PLAN COMMISSION MEETING AGENDA

TUESDAY, March 24, 2015
AT 6:00 PM

MINUTES OF THE
OAK CREEK PLAN COMMISSION MEETING
TUESDAY, MARCH 10, 2015

DRAWN BY	J.OSGOOD
SCALE	MULTIPLE
PROJ. NO.	0001
DATE	2014-10-29
SHEET	SP1

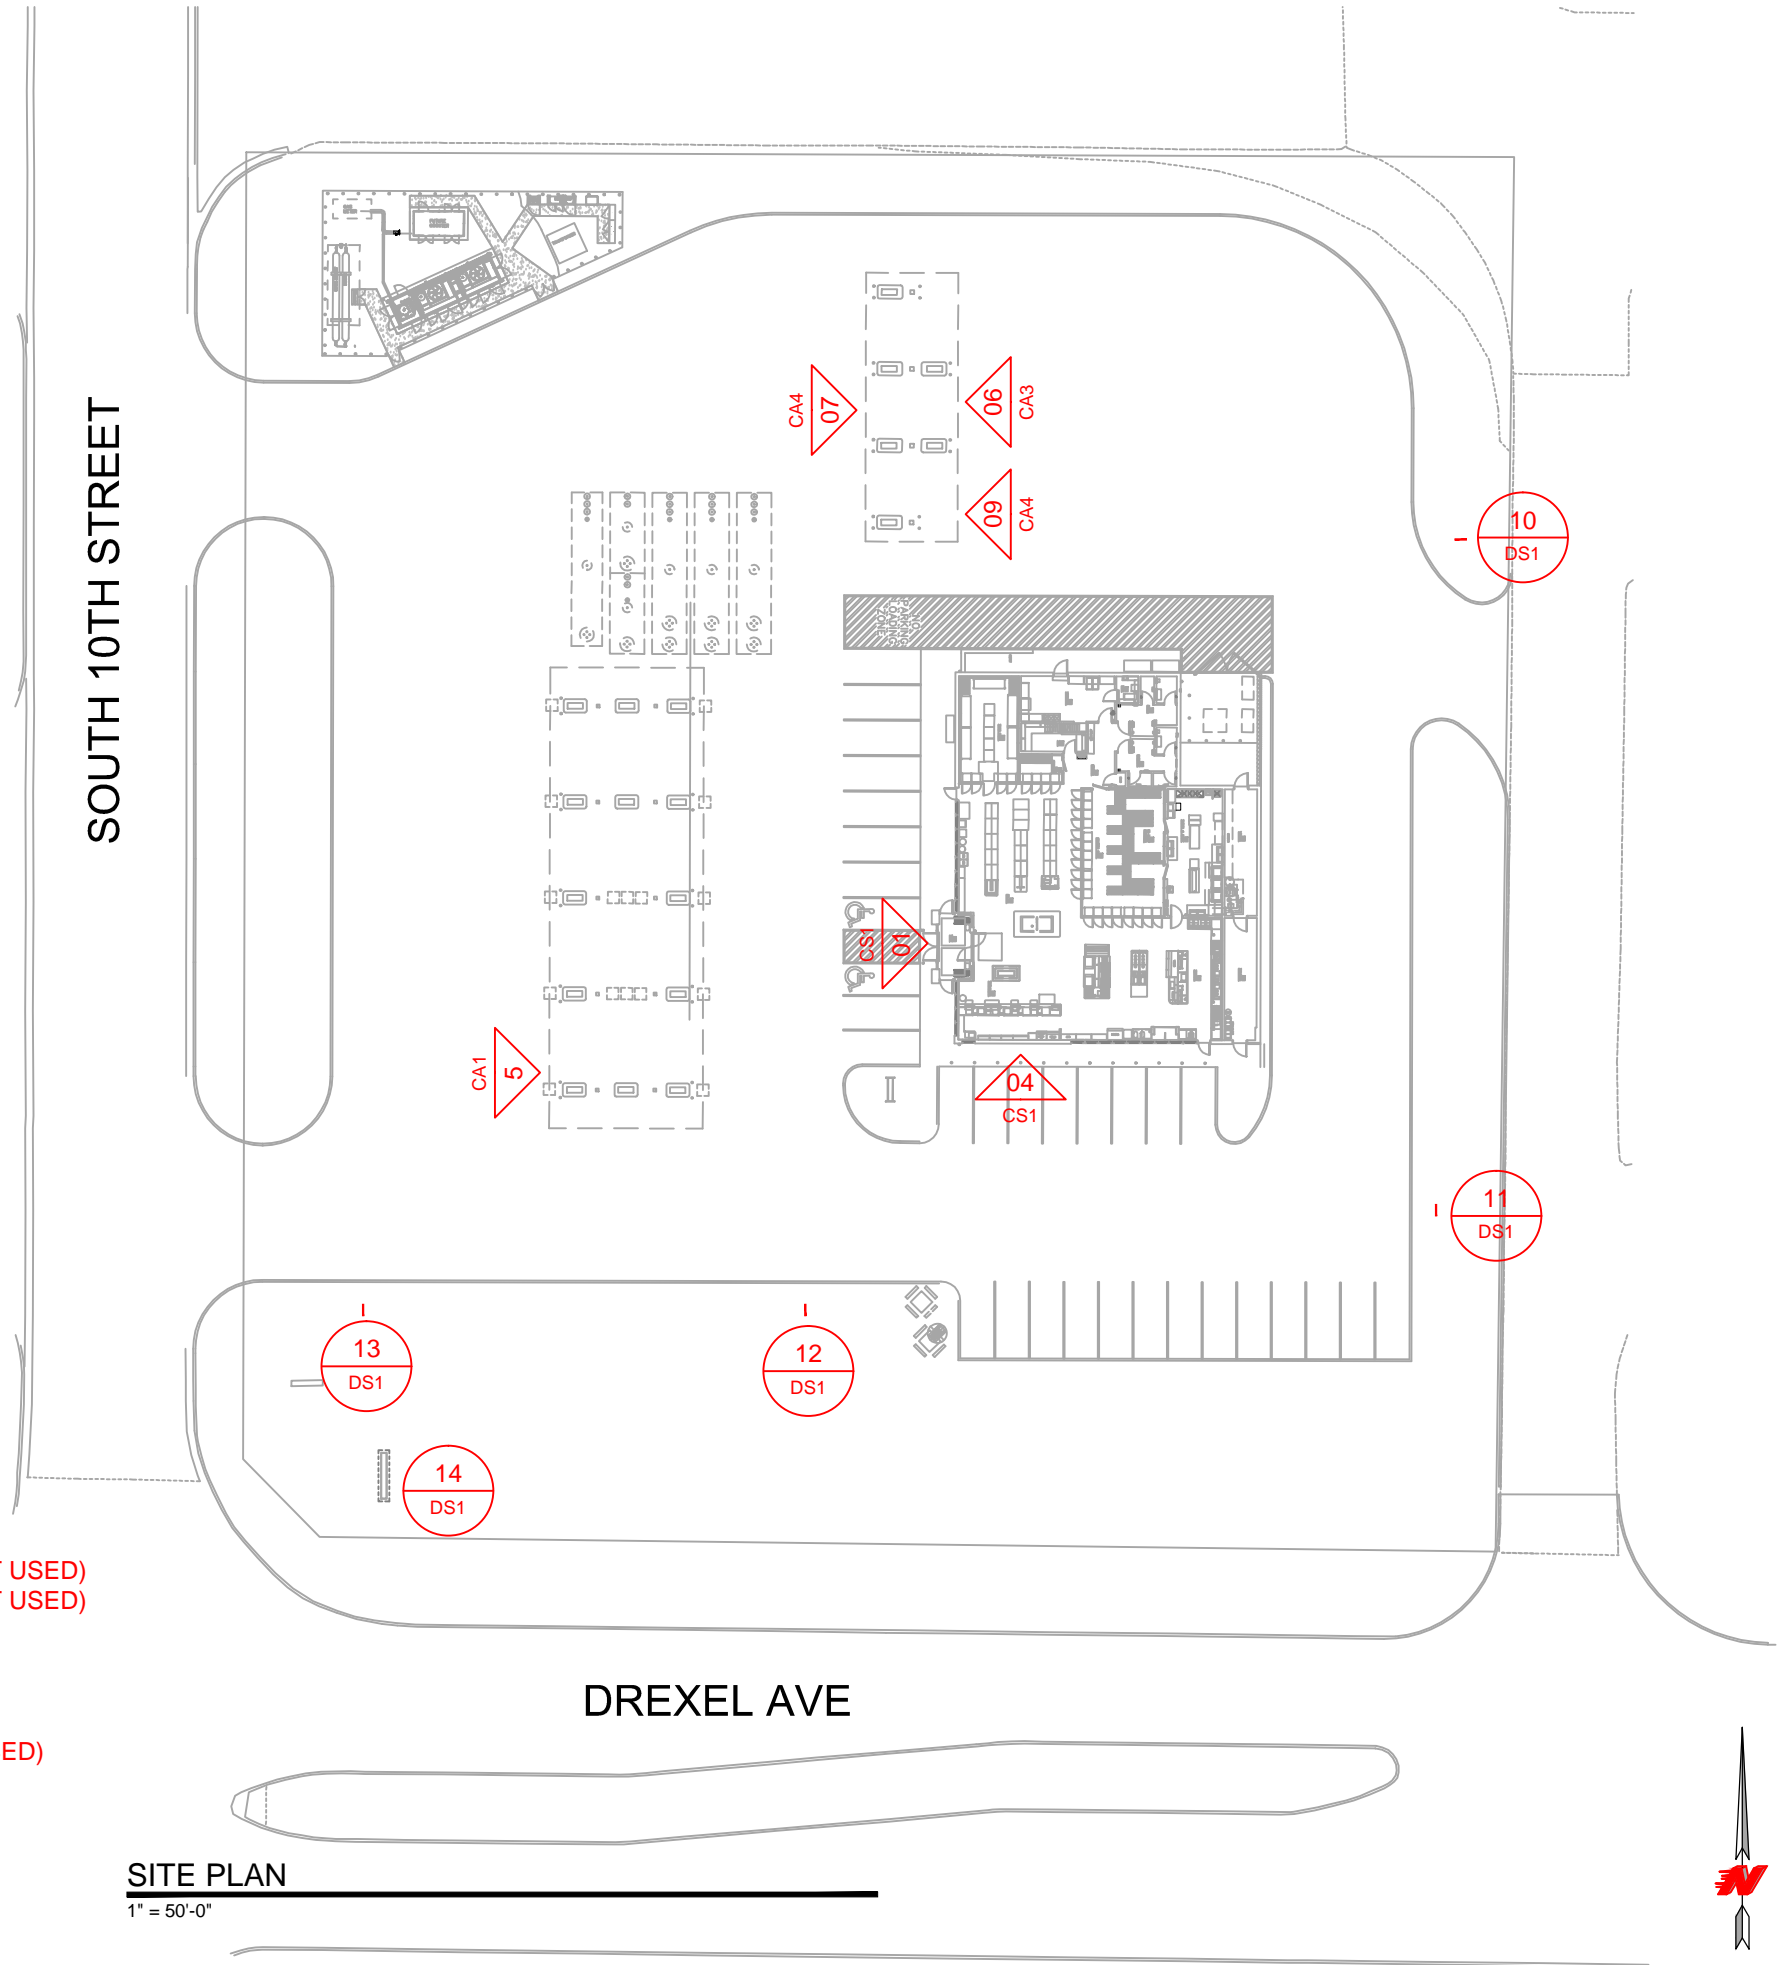
Commentary: The applicant is requesting a variance from the Oak Creek Municipal Code Section 17.0706(j)(3) which states that Gasoline and/or service stations may provide one ground or pole sign displaying the name of the station and the brand and price of gasoline sold. One wall sign per street frontage may also be provided.

This Instrument was drafted by Rick R. Hillmann, a Professional Land Surveyor, S-3005 on this XXxx day of MONTH, 2015 Sheet 1 of 5

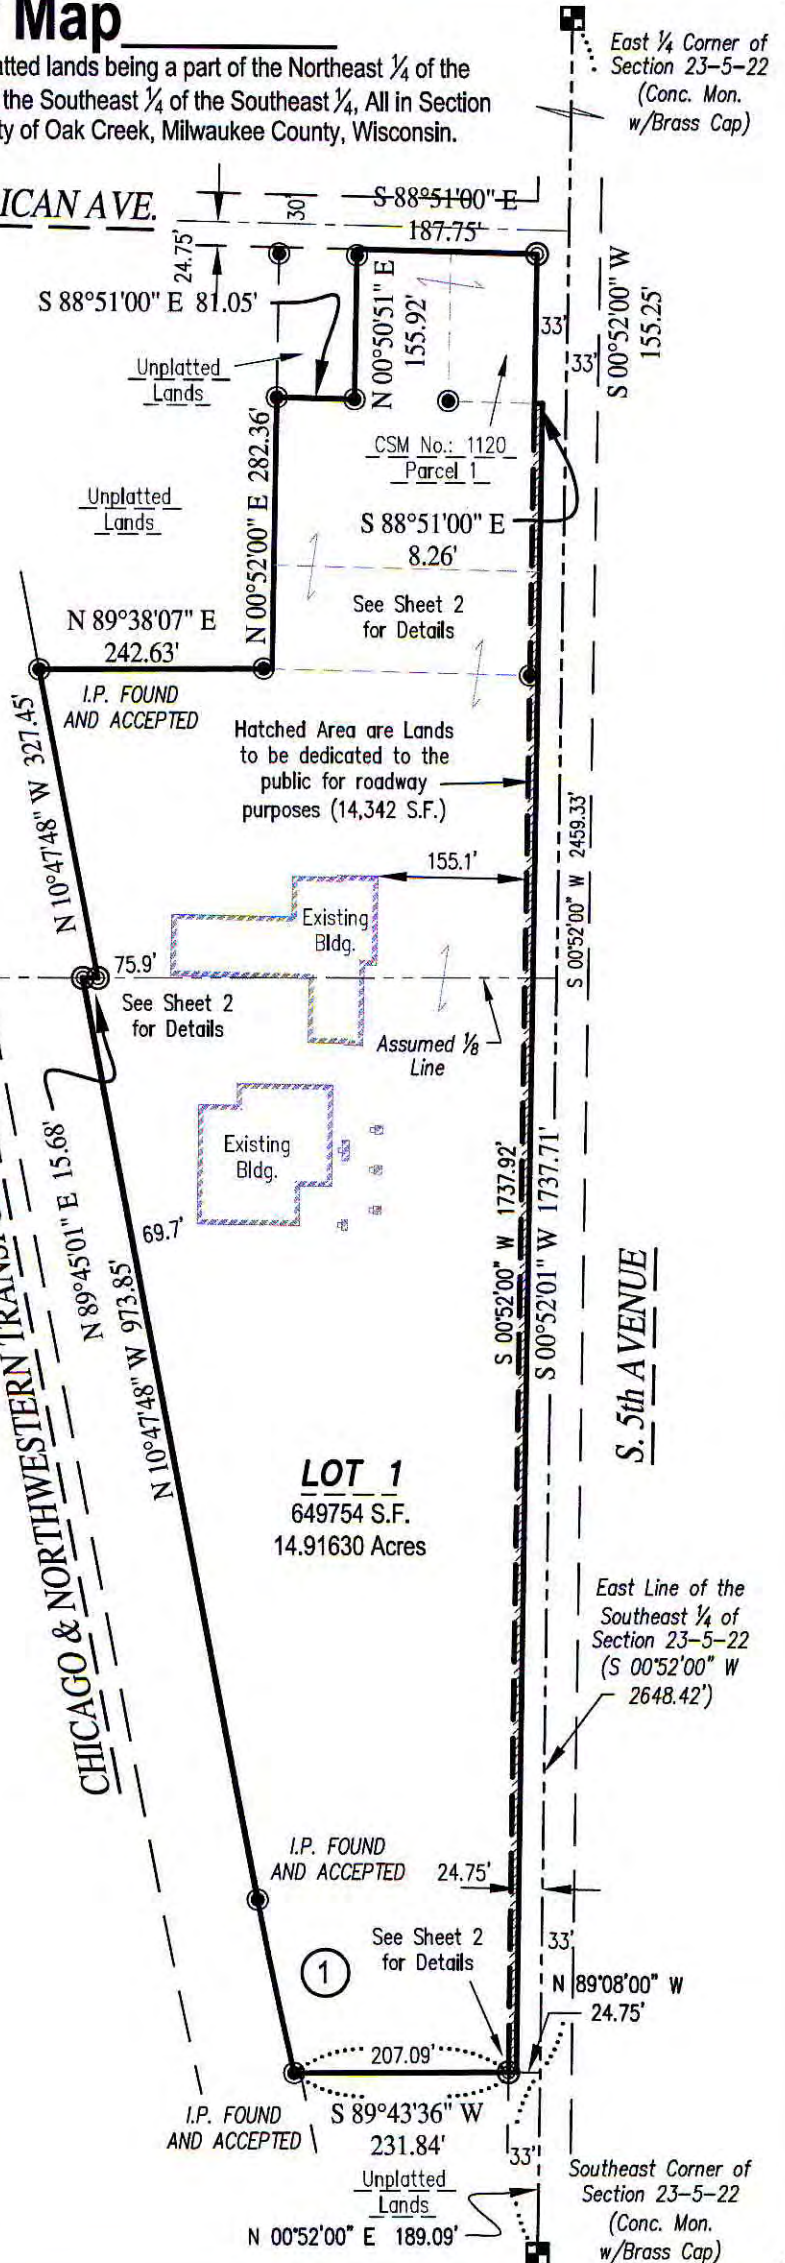
Several changes will be required on the map prior to recording, including wetland boundaries, easements, and an incorrect bearing. These are listed as conditions above.

1. That all wetlands are delineated and boundaries included on the map prior to recording.
2. That all easements are included on the map prior to recording.
3. That all technical corrections, including the updated bearing on Sheet 3, are made prior to recording.

PROJECT: Plan Review – Ron Pritzlaff, Oak Creek Water and Sewer Utility

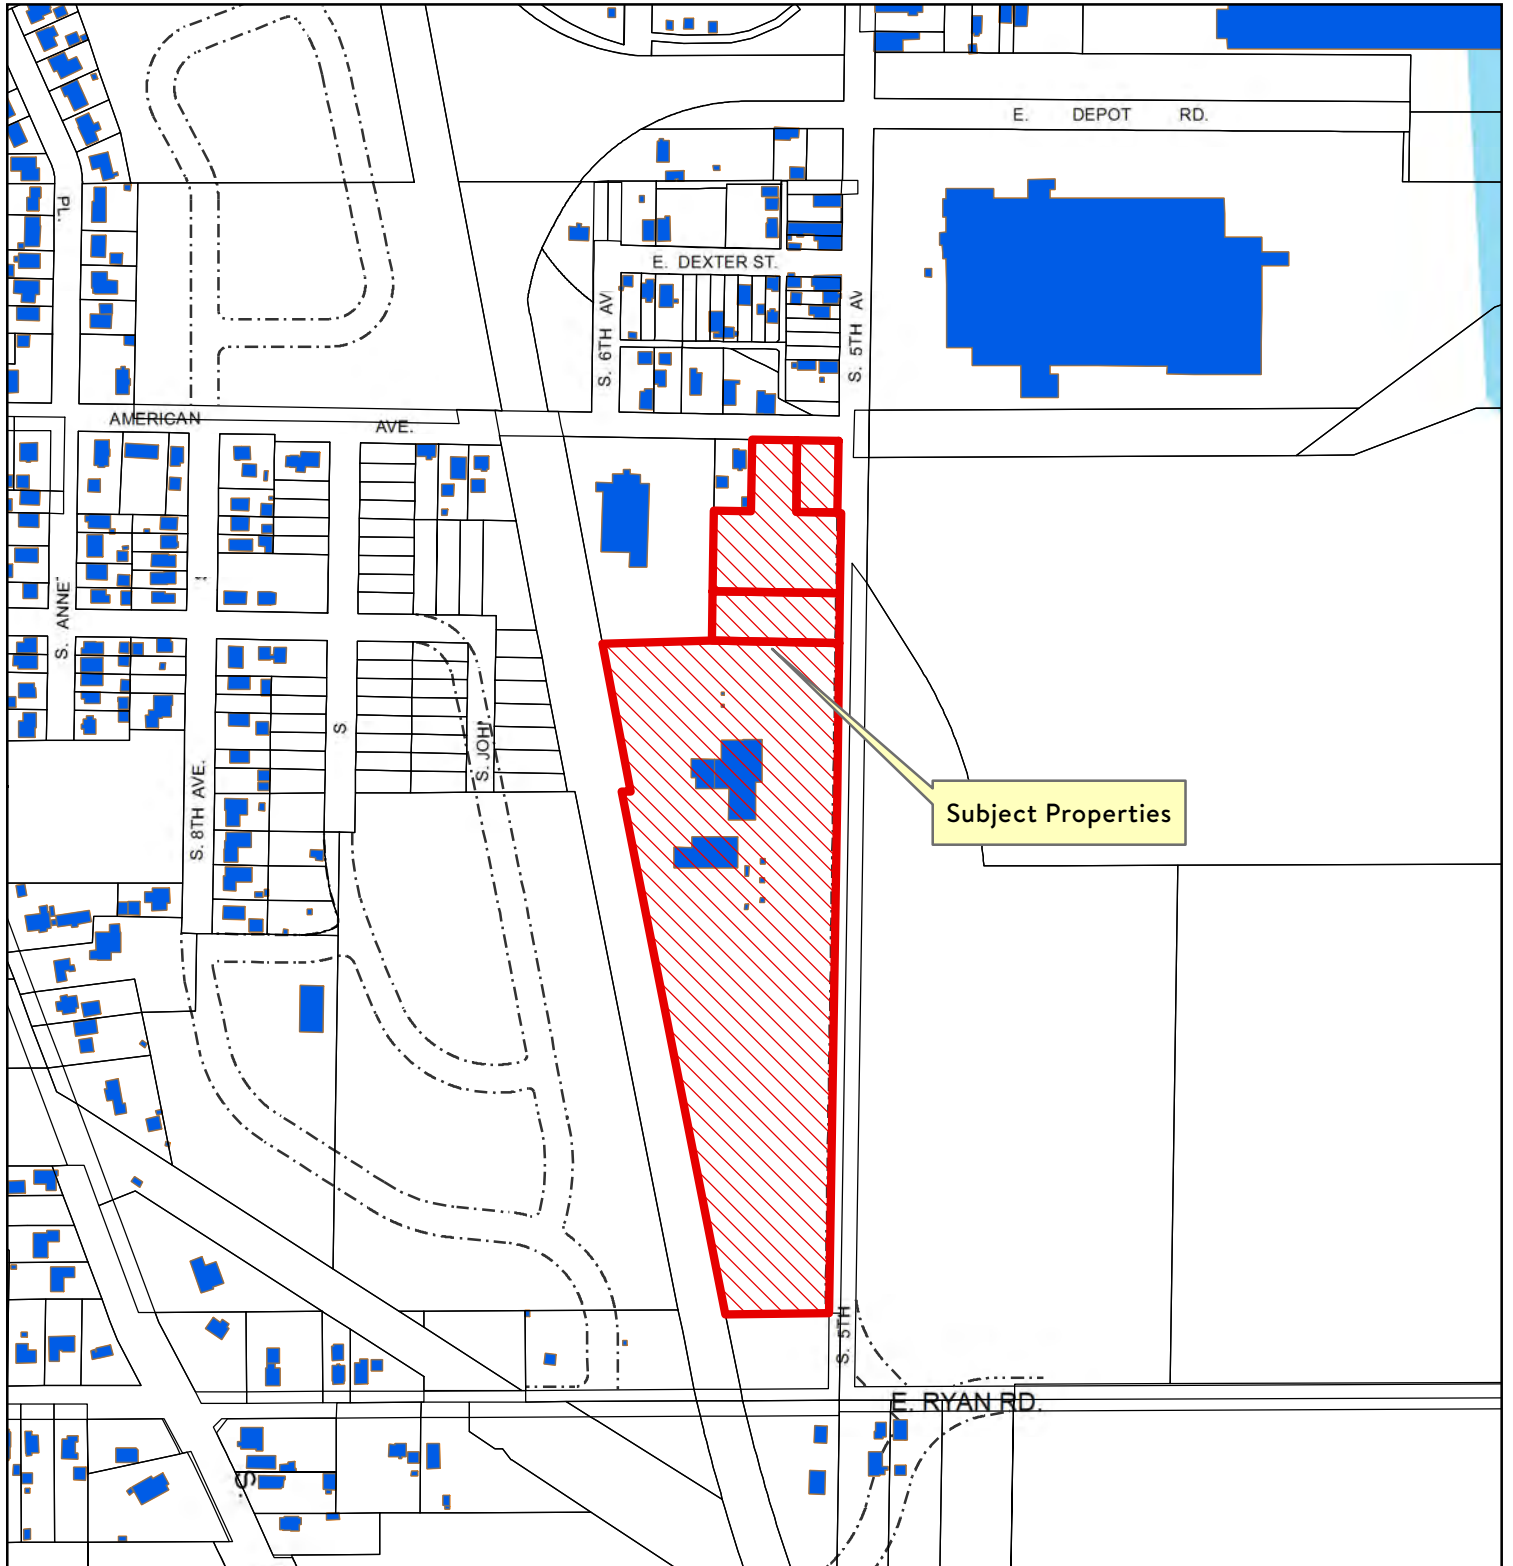
The proposal includes the construction of a high service pump facility on the northeast, intermediate pump facility on the west behind the existing building, ultraviolet (UV) light disinfection adjacent to the intermediate pump station, storage behind the high service pump facility, and related appurtenances. All locations are per the plan approved in the Conditional Use Permit. No additional parking is required or proposed for the project as the buildings are for mechanical and related equipment only (no office space). These new facilities will be accessed via a new asphalt access road that varies in width from 20 feet to 25 feet. An 8-foot tall decorative security fence with a 24-foot-wide sliding access gate at the new access road will be extended around the new construction to the existing security fence on the property. Required opacity will be determined by the Plan Commission.

Landscaping plans have been submitted to screen the proposed facilities from the single-family residence to the northwest, American Avenue, and 5th Avenue. Although not clearly shown on the color renderings that are included in this packet, there will also be a stormwater basin on the northeast portion of the property. Chapter 17 requires a minimum 3-foot landscape area around buildings. No landscaping is proposed around the intermediate pump/UV station due to its location. A 2-foot landscape zone is proposed around the south, east, and northwest corner of the high lift pump station. To the north of the access road is an additional 18-foot wide vegetation area. Between the stormwater basin and the residential property on the northwest is a landscape berm, with a dense mix of shade, evergreen, and ornamental trees along the south and around the southeast corner of the residential property. Flowering and shade trees are scattered between the landscape berm and the storage tank, as well as around the proposed stormwater basin. Comments from the City Forester indicate that some of the species and sizes of trees and plants should be changed. Staff suggests relocating or adding landscaping around the exterior of the security fence rather than behind it.

STAFF RECOMMENDATION: That the Plan Commission approves the site and building plans submitted by Ron Pritzlaff, Oak Creek Water and Sewer Utility, for the properties located at 9175, 9235, and 9325 S. 5th Ave., 3975 E. American Ave., with the following conditions:

1. That all building and fire codes are met.
2. That stormwater and grading plans are submitted for approval by the Engineering Department prior to issuance of building permits.
3. That updated landscaping plans are submitted to the Department of Community Development for review and approval prior to the issuance of building permits.
